ADDENDUM NO. 02

Project:
Sheridan HS and MS School Renovation Project

Owner:
Sheridan Community Schools
24795 Hinesley Road
Sheridan

This Addendum #02, Dated 09.12.2025, forms part of the contract documents and modifies the original Bidding Documents dated 08.15.2025. Please acknowledge receipt of this Addendum in the space provided on the Bid Form. Failure to acknowledge this Addendum may subject the Bidder to disqualification.

DRAWING TITLE:
**GROUND FLOOR
PLAN - UNIT D -
POWER AND
SIGNAL**

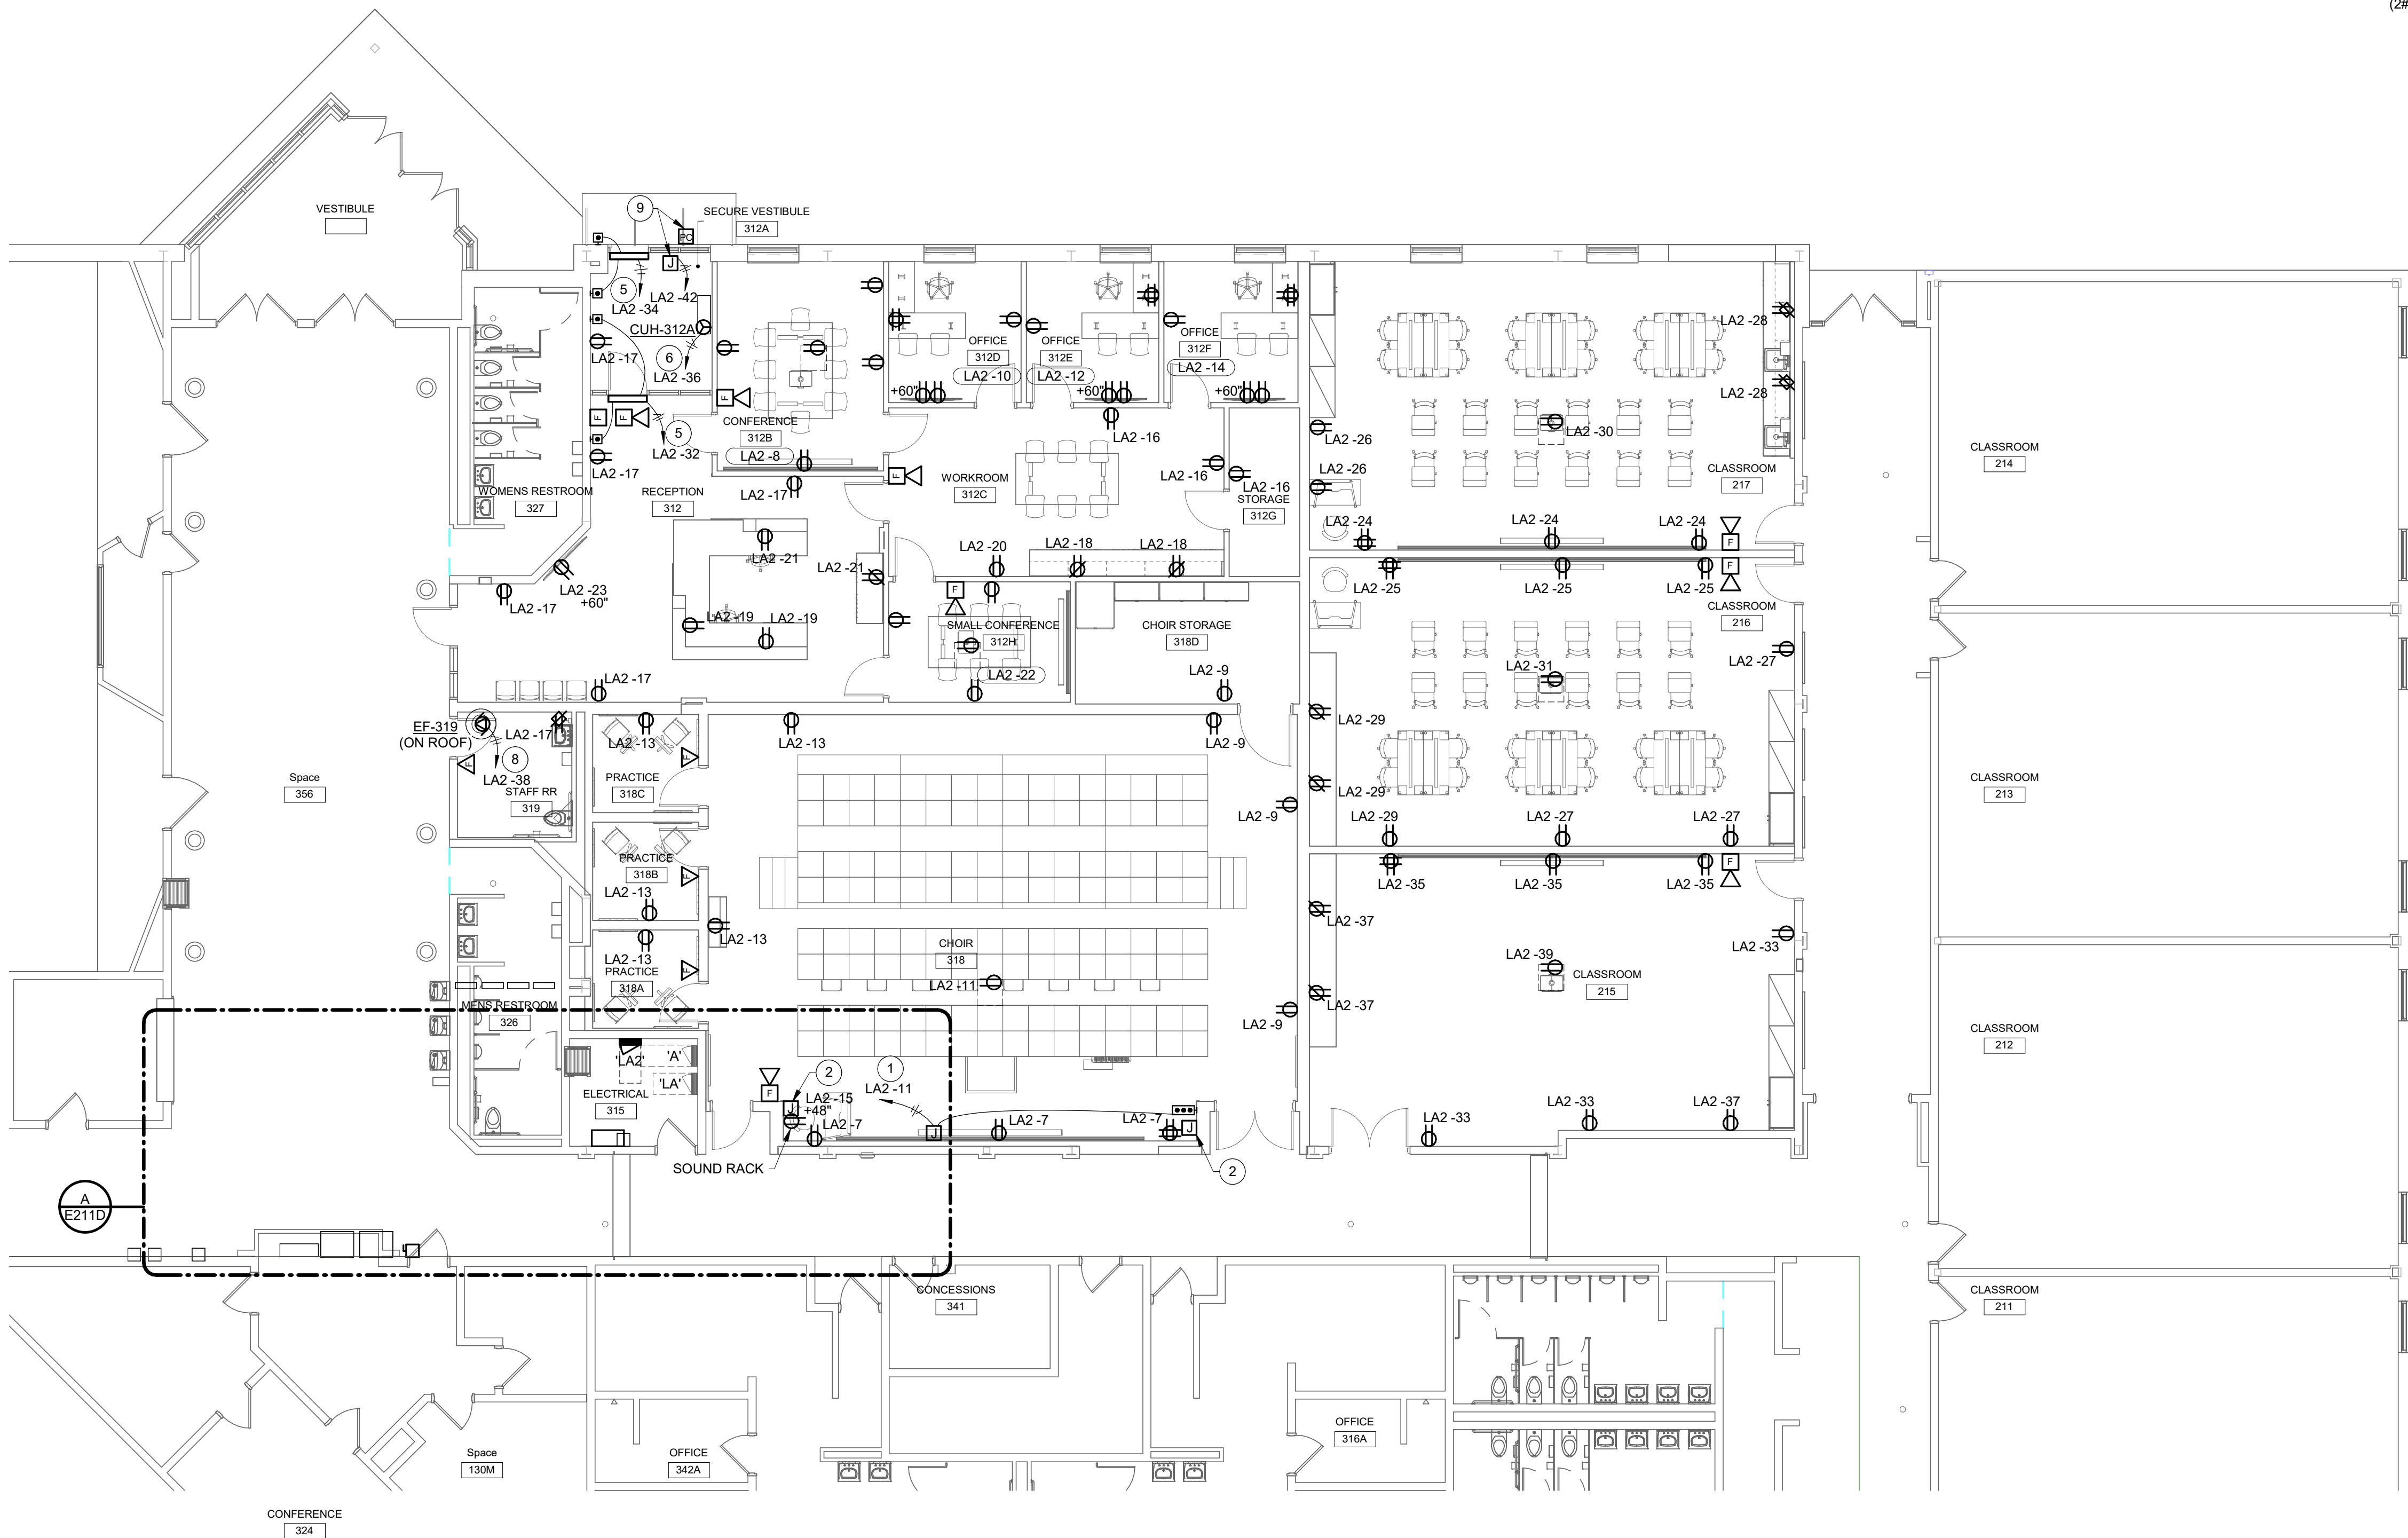
- A. Edited circuit number on drawing.
- B. Edited Plan Note 4.
- C. This drawing is to be reissued in its entirety.

15. Bid Item #14 Electrical Contractor shall note the changes made to Drawing E201B, E201D, E211A, E211D, E601.
16. Note: Bid Item #14 Electrical Contractor shall note the ceiling material changes per the Addendum #01, Drawing A210B, at the Grow Lab Room 125D, therefore Bid Item #14 Electrical Contractor will need to change the Light Fixtures from a ceiling mount type to a lay in on Drawing E201B.

GROUND FLOOR UNIT A - TELECOMMUNICATIONS DEMOLITION

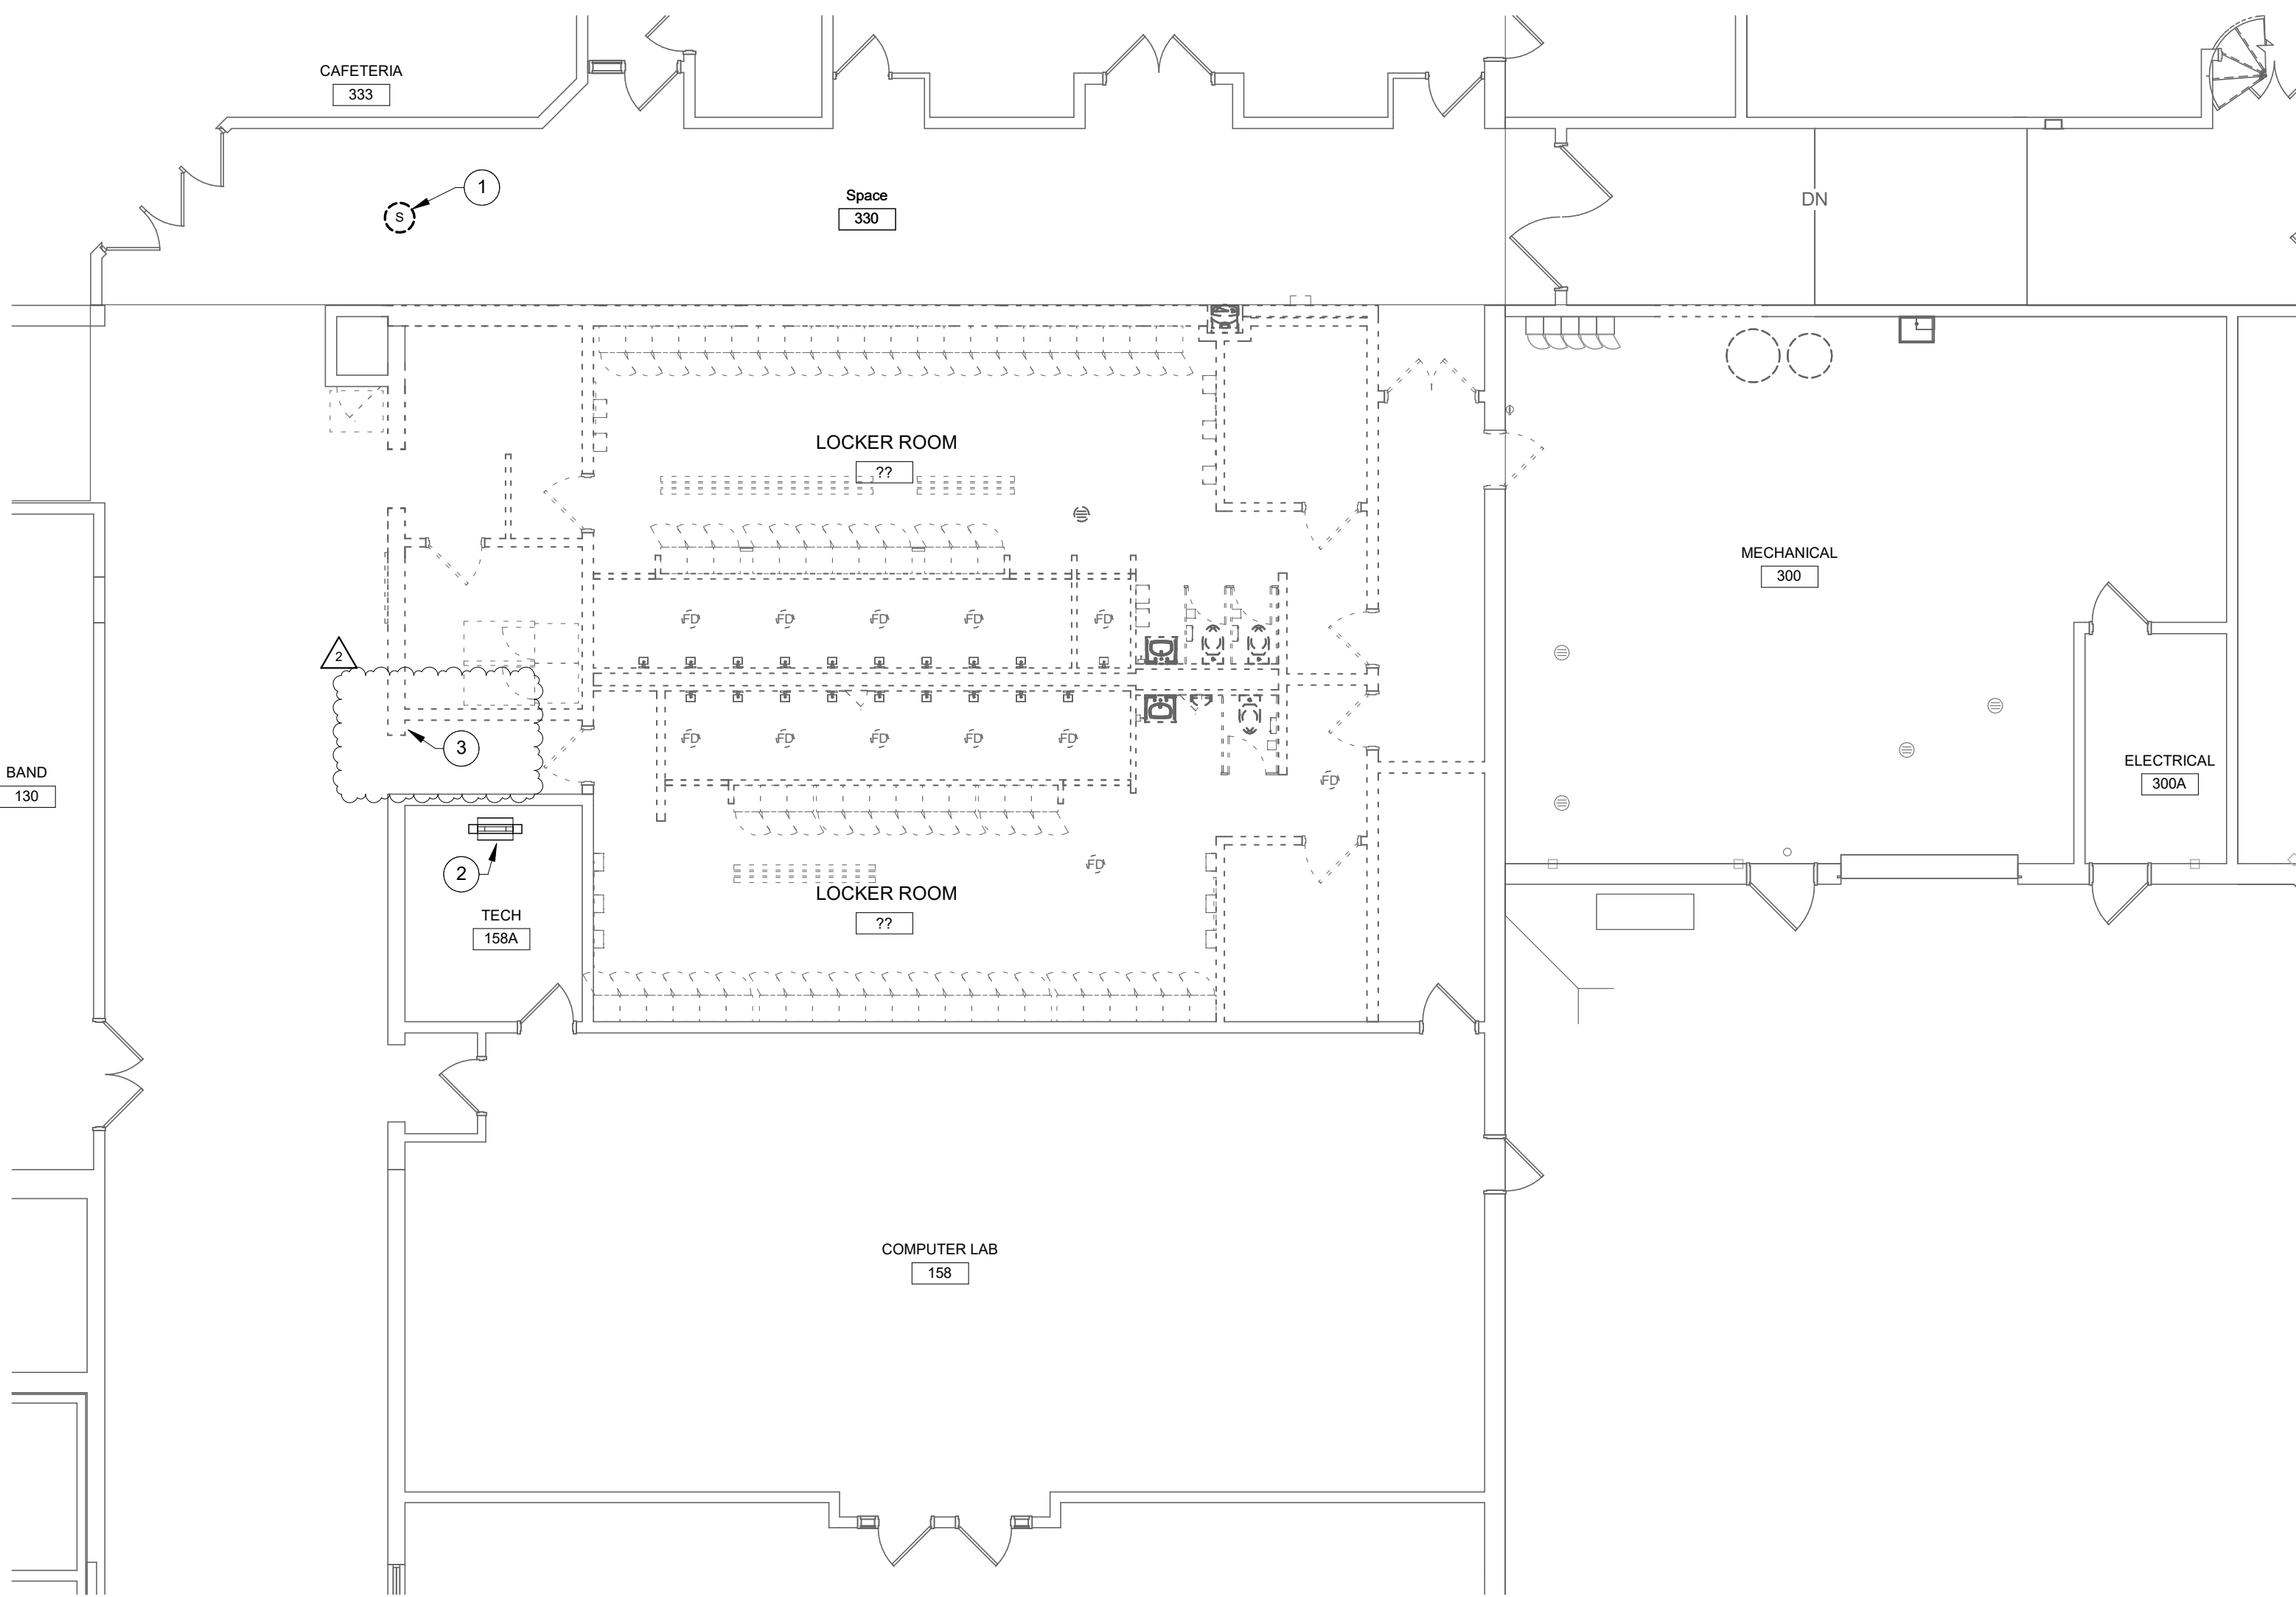
- A. Plan Note #3: REMOVE TELECOM ENCLOSURE AND WIRING IN WALL COMPLETELY. CONTRACTOR TO VERIFY IF ANY WIRING IS ACTIVE BEFORE DEMOLITION. REROUTE ACTIVE WIRING.

17. Bid Item #14 Electrical Contractor shall be responsible for Plan Note 3 on Drawing TD201A.
18. Bid Item #01 General Trades Contractor, amend Scope of Bid, Line Item #151 to read: Bid Item #01 General Trades to furnish and install the "TB1" metal framed tackboard assemblies like shown in the Choir Room details 1 and 3 on A601 and per A800 and per specs 10 11 00.
